# SERVICE LETTER

No. 694

- I. Tailpipe Support Installation
- II. Exhaust Manifold Clamp Inspection (reference attached Lycoming Service Bulletin No. 368, dated November 23, 1973)

PA-31P Navajo

Rear View Showing Tensioning Devices

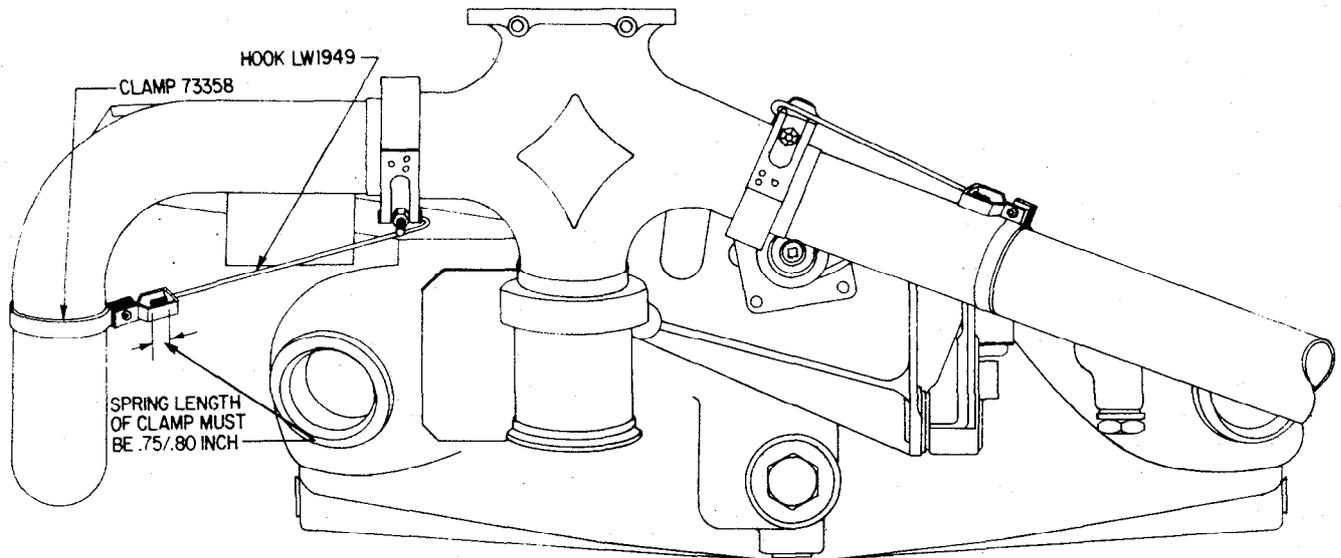
As a means of preventing the exhaust manifold from separating at the slip joint, thus losing the exhaust pressure to the turbocharger, a tensioning device is provided on the exhaust manifold which consists of a clamp, hook and spring as shown in the illustration.

Examine the clamp for any movement; if it can be moved in any direction, it is not tight enough. To tighten, draw the nut on the bolt as far as possible. If the clamp can still be moved, remove the nut and bolt leaving the clip and hook loose. Fasten both tangs of the clip on the outside of the tangs of the clamp as shown in the

illustration. If the clamp still can be moved, replace the component parts with those shown in the list below.

The compressed length of spring is .75-.80 inch.

| (1) | No. 73358    | Clamp  |
| (1) | No. 1892     | Spring |
| (1) | No. LW-11949 | Hook   |
